February 12, 1992
LD-92-016

Subject: Response to NRC Requests for Additional Information

Reference: Letter, Structural and Geosciences Branch RAIs, T. V. Wambach (NRC) to
E. H. Kennedy (C-E), dated September 26, 1991

RESPONSE TO NRC REQUESTS FOR ADDITIONAL INFORMATION
STRUCTURAL AND GEOSCIENCES BRANCH

Figure 220.18-1 • SSI Analysis Flow Diagram

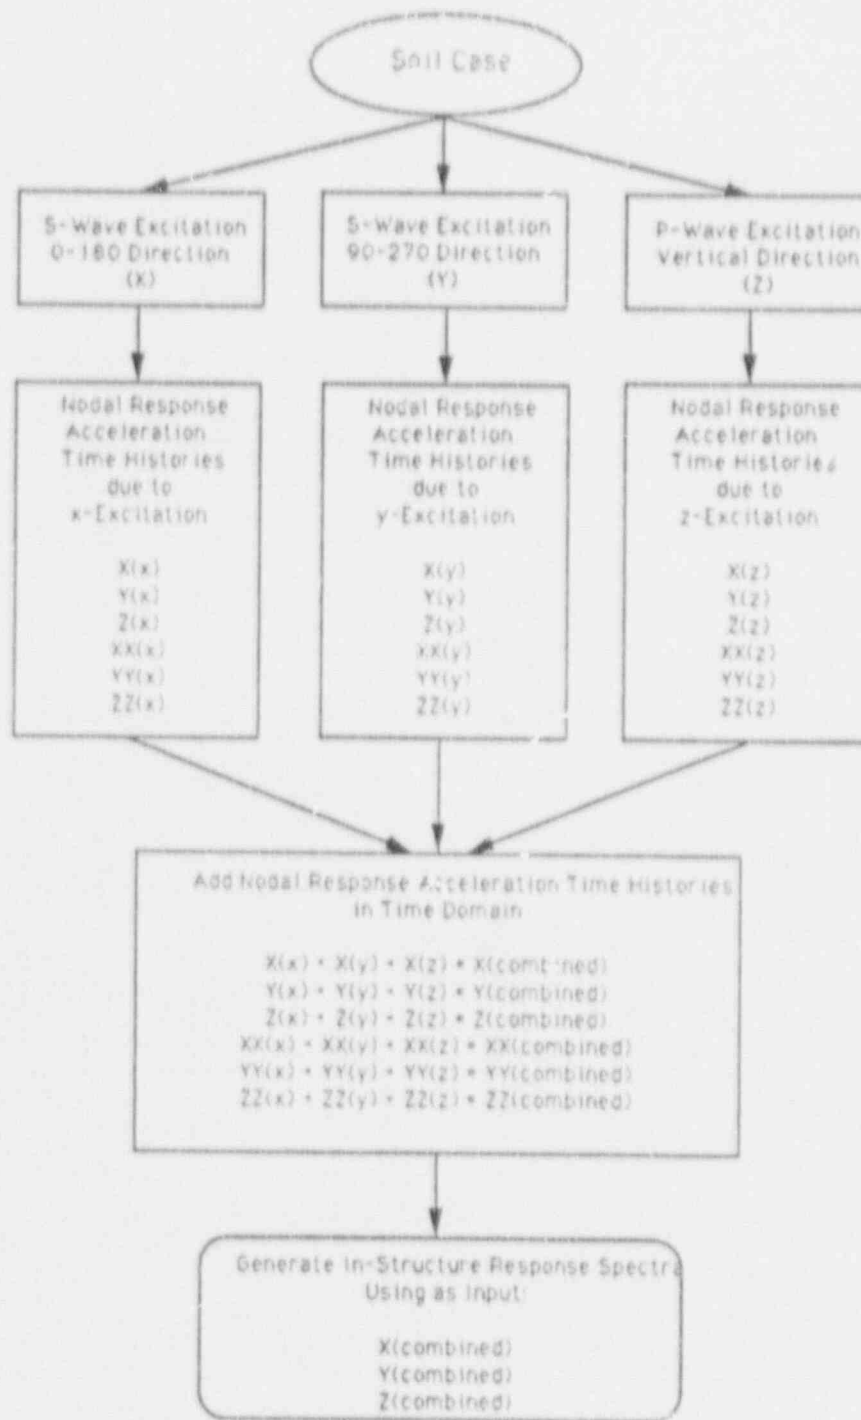
Section 3.7.2.1.2.1 - How many SASSI computer runs were performed for all soil conditions considered in Section 3.7.1.1? It is expected that there are a lot of time histories available because there are many soil cases and there are at least one P-wave and two S-waves. How were the basemat acceleration time histories obtained in these runs used for the analysis of various NSSS models described in Section 3.7.2.1.2.1 and Figures 3.7-32 through 3.7.39? Provide responses to these questions also for the combined model and the structures discussed in Section 3.7.2.1.1.

For each of the above cases, SASSI runs were performed according to the sequence shown in the flow diagram of Figure 220.18-1. For horizontal excitation, two runs were performed using vertically propagating S-waves, one with excitation in the 0-180 direction and one with excitation in the 90-270 direction. For vertical excitation, one run was performed using vertically propagating P-wave. For each of the three runs, at every node of the structure, response was obtained at all six degrees of freedom, i.e., three translational (X, Y, Z) and three rotational (XX, YY, ZZ). The response time histories at each degree of freedom were subsequently added algebraically in the time domain to obtain the combined response time histories due to the three excitations. Finally, the combined response time histories were used as input to generate response spectra at the selected building locations.

Amendment I
December 21, 1990**SYSTEM 80+™**STICK MODEL OF INTERNAL STRUCTURE
(FOR HORIZONTAL ANALYSIS)

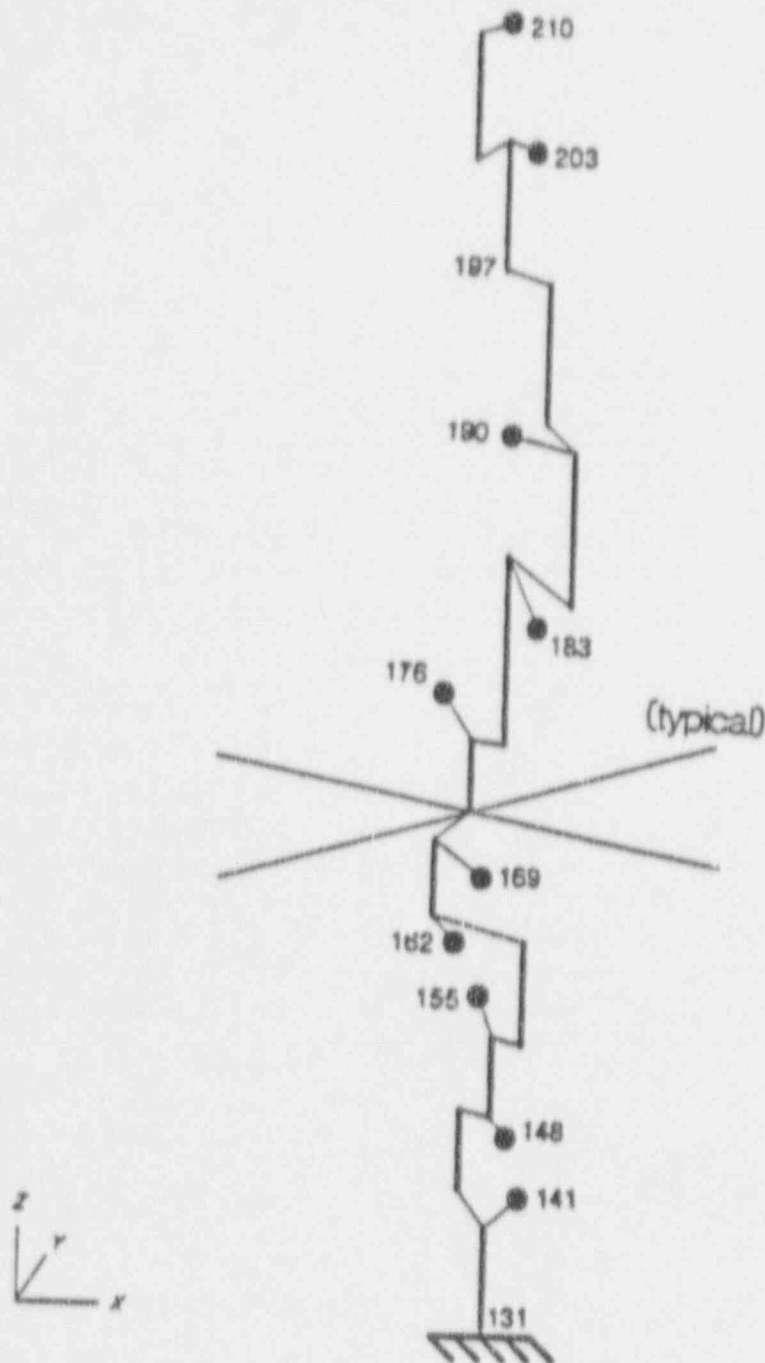
Figure 3.7-28 shows the stick model of the internal structure for horizontal seismic analysis. Provide a figure of the stick model used for vertical seismic analysis. (see also Comment 220.24)

The stick model shown in Figure 3.7-28 is typical of the horizontal and vertical model. The nodes shown represent the mass nodes which are at the same location in both models. The difference in the models is the x-y plane location of the sticks, which are at the center of rigidity. The sticks represent the stiffness between floor elevations. The horizontal model sticks are located at the shear center of the section. The vertical model sticks are located at the bending center of the section.

Figure 3.7-28 will be revised in a future amendment to CESSAR-DC to clarify this.

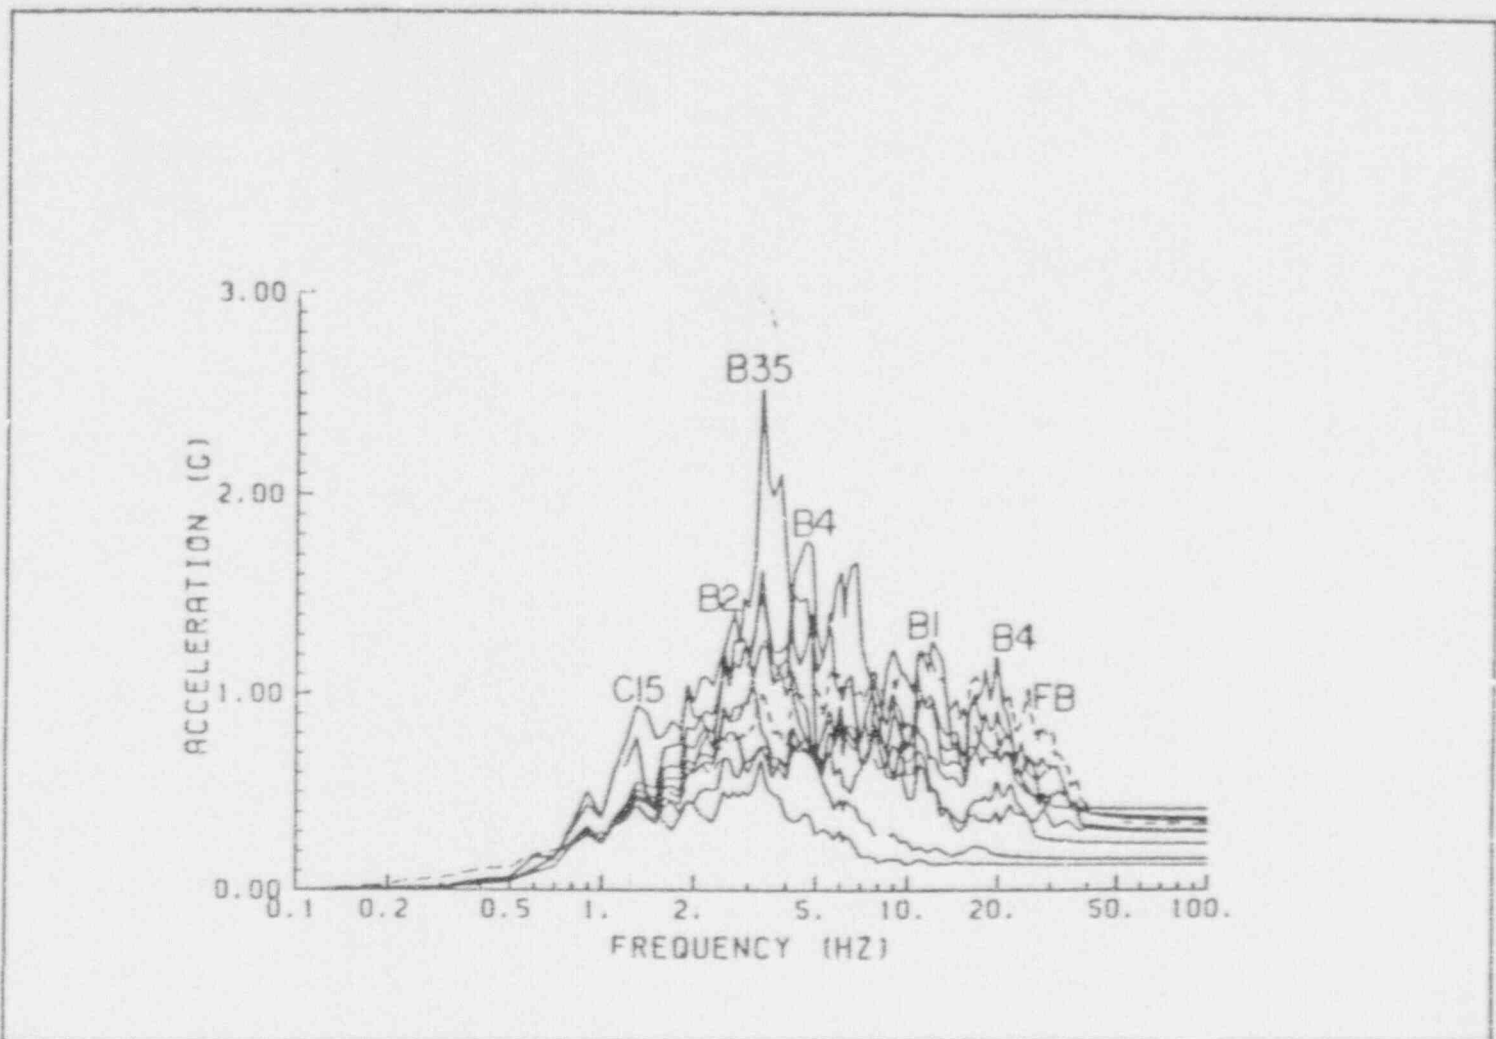
Figure 3.7B-5 has the same title as Figure 3.7B-6. Provide correct titles.

Figure 3.7B-5 should read "(..., 0°-180° direction)", not "(..., vertical direction)". The Figure 3.7B-6 title is correct.

The title to Figure 3.7B-5 will be corrected in a future amendment to CESSAR-DC.

RAI 22039

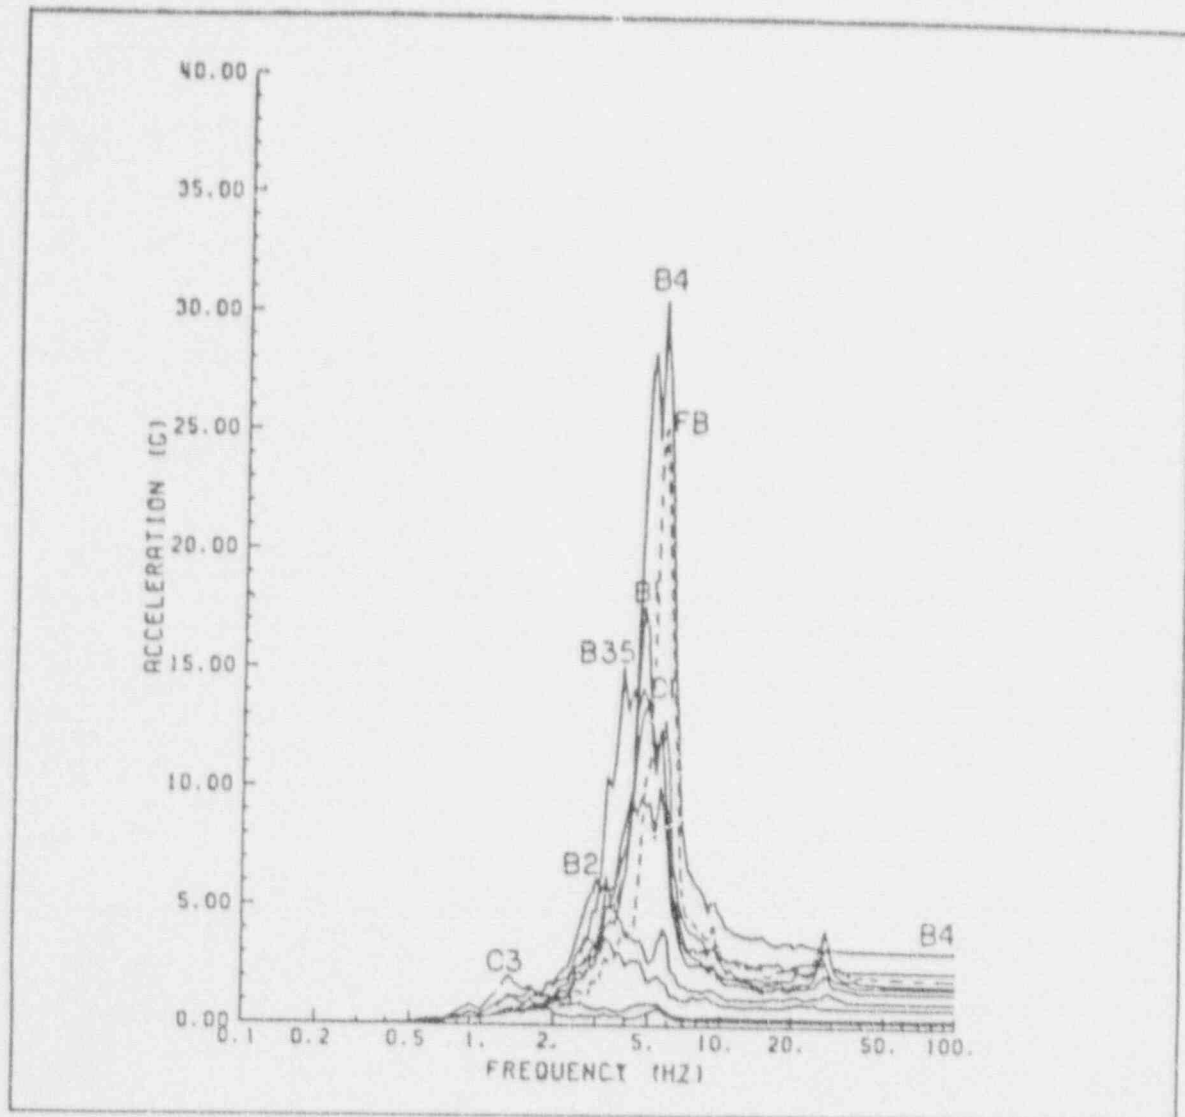
The Figure 3.7B-11 title should read "(... , 0-180 direction)", not "(... , vertical direction)". The title for Figure 3.7B-12 is correct.

The Figure 3.7B-11 title should read "(... , 0°-180° Direction)", not "(... , Vertical Direction)". The title for Figure 3.7B-12 is correct. The title to Figure 3.7B-11 will be corrected in a future amendment to CESSAR-DC.

Fig. 1 Range of Modulus Reduction Curves for Clays and for Sands

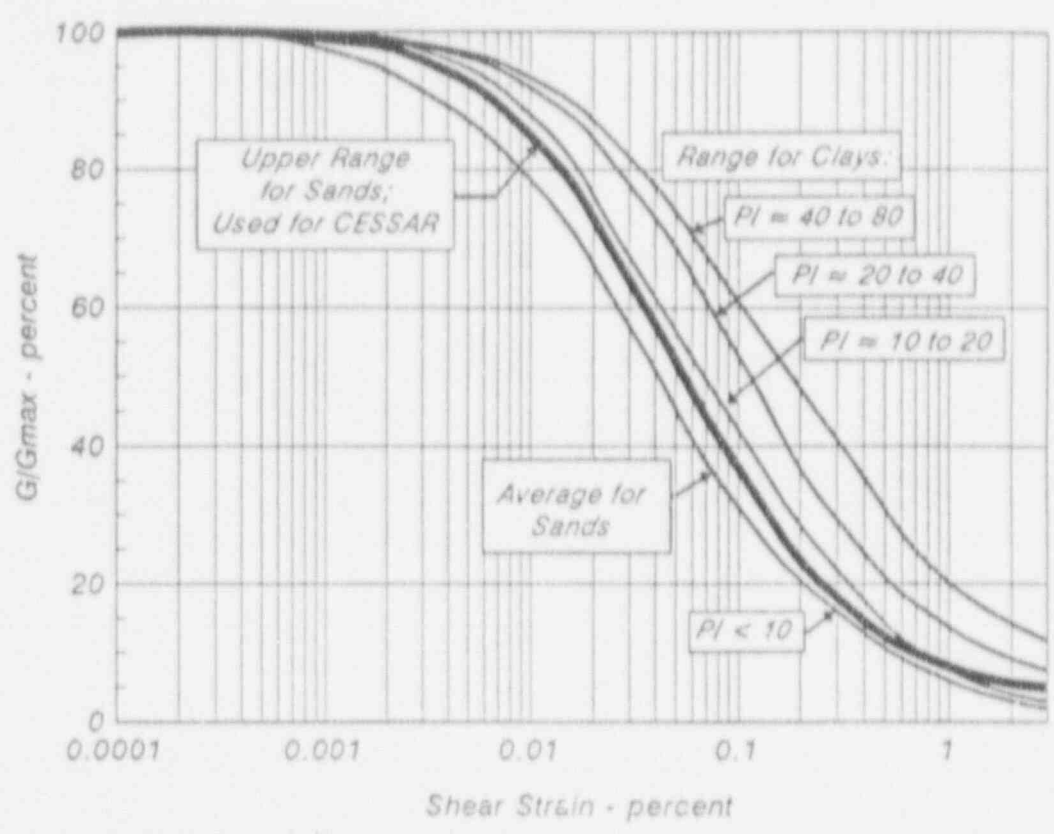
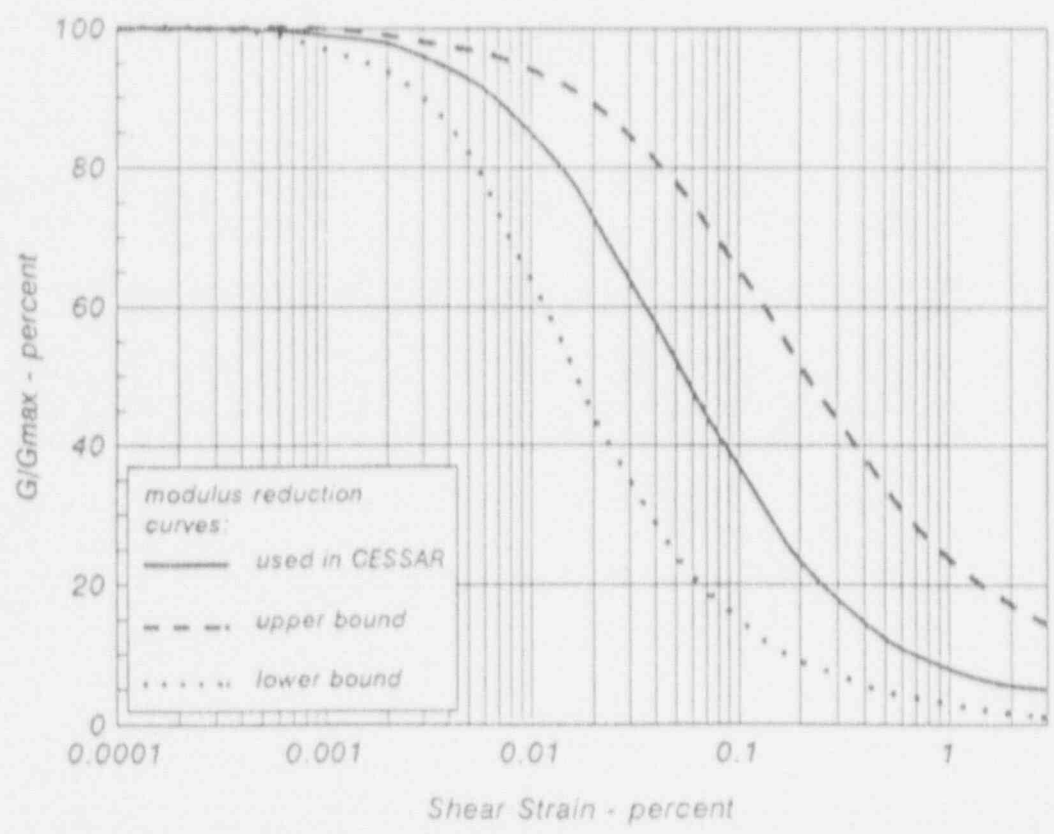
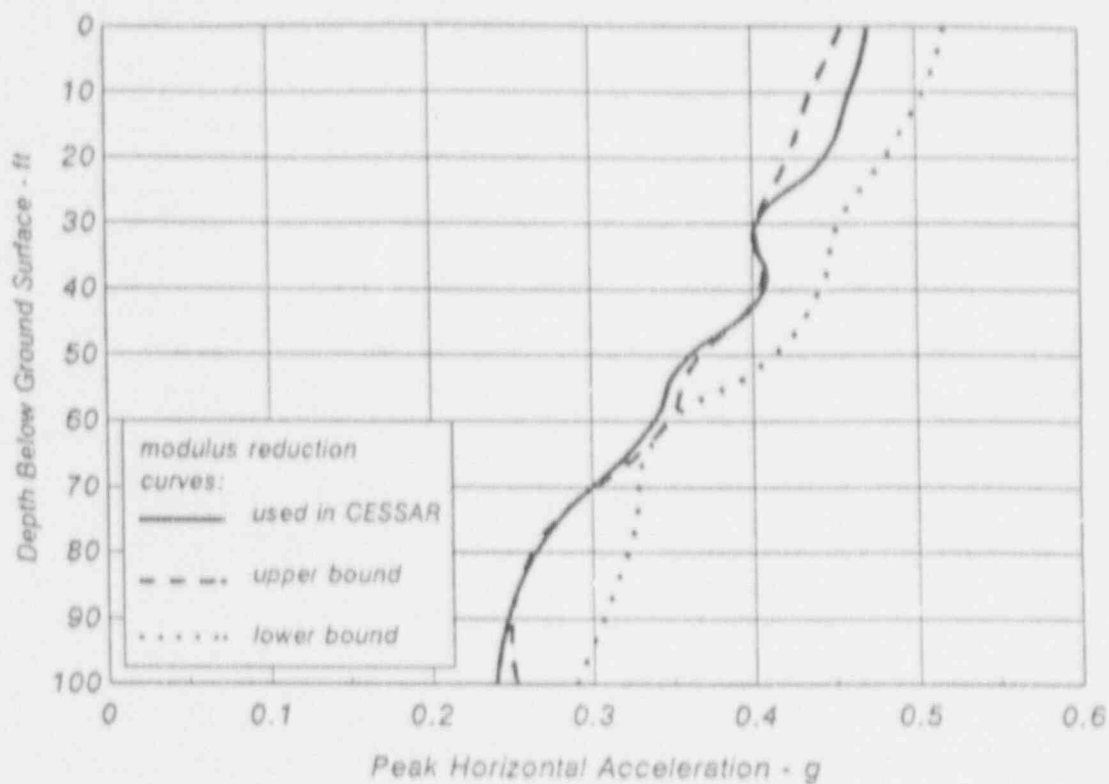
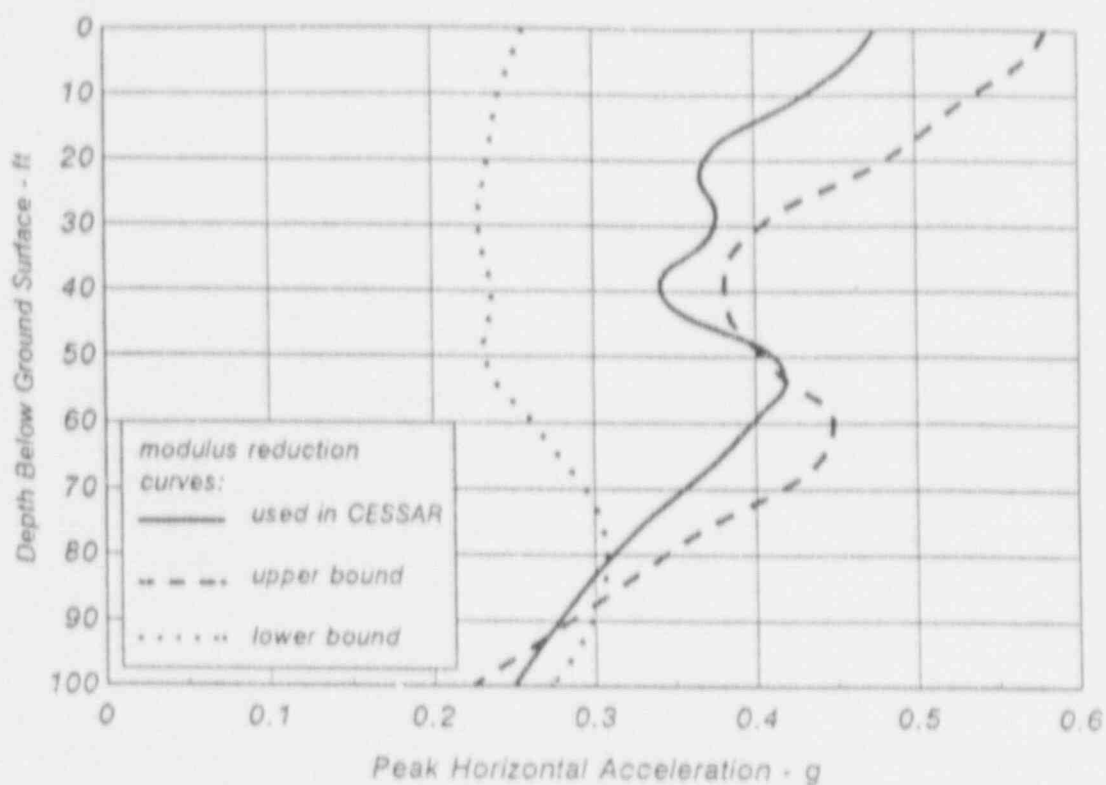
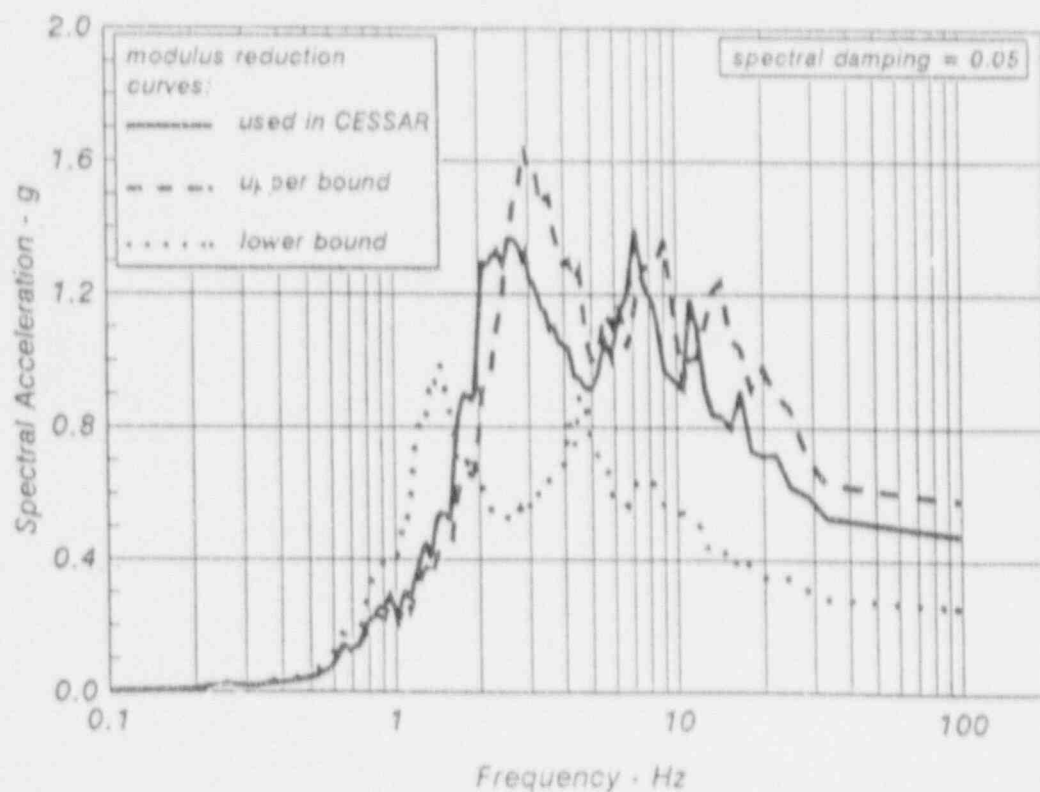
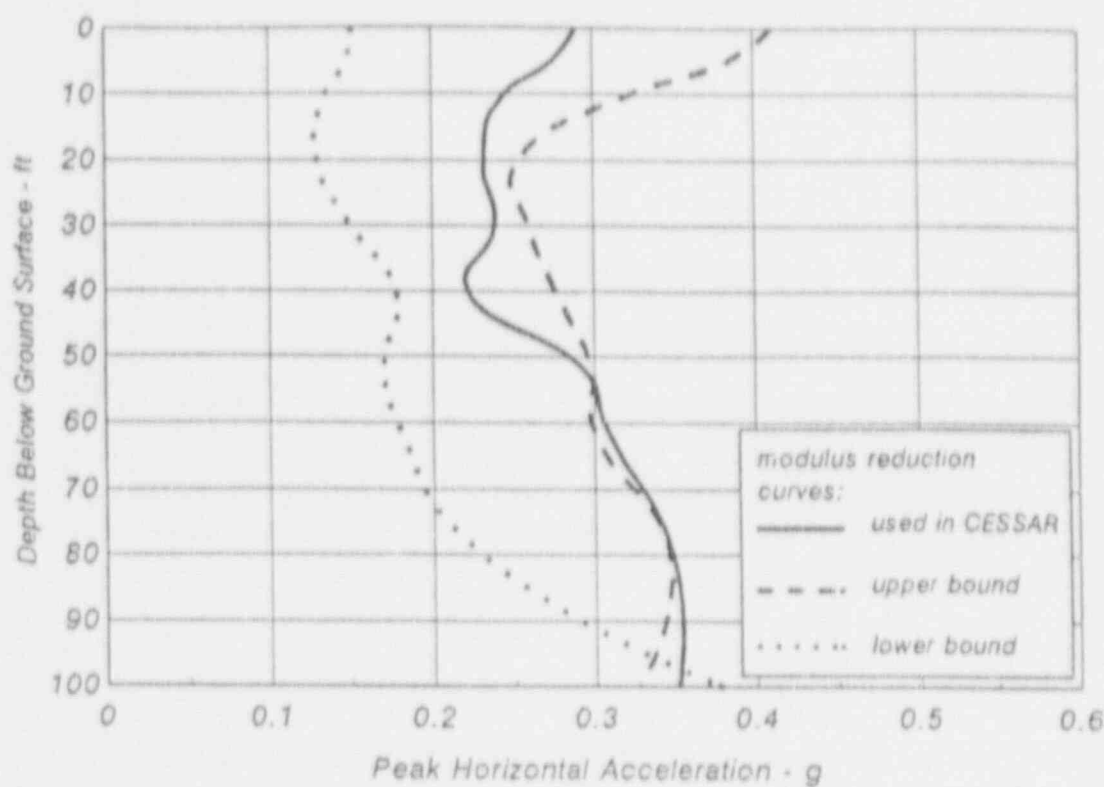
Section 2.5.2.5.2 - Why are the upper bounds (non-conservative) of the shear modulus shear strain relationship (Figure 2.5-3) published by Seed and Idriss selected?

Available modulus reduction curves for cohesionless as well as cohesive soils are presented in Figure 1; the term PI shown in Figure 1 is the plasticity index. Note that the lower range of the modulus reduction curve originally published by Seed and Idriss (1970) is not shown in Figure 1 and that the curve labeled $PI < 10$ is approximately equal to the average modulus reduction curve published by Seed and Idriss for sands.

The results of these response calculations are presented in Figs. 3, 4 and 5 for Cases B-1, B-2 and C-3, respectively. The upper part of each figure shows the variations of peak horizontal accelerations with depth and the spectral ordinates calculated at the ground surface are shown in the lower part of each figure. These results indicate that "conservatism" is not necessarily obtained by selecting either the lower or the higher modulus reduction curve. Nevertheless, the wide range of soil depths and shear wave velocities used in System 80+ design as described in CESSAR-DC covers the potential variations indicated by the results presented in Figures 3, 4 and 5.
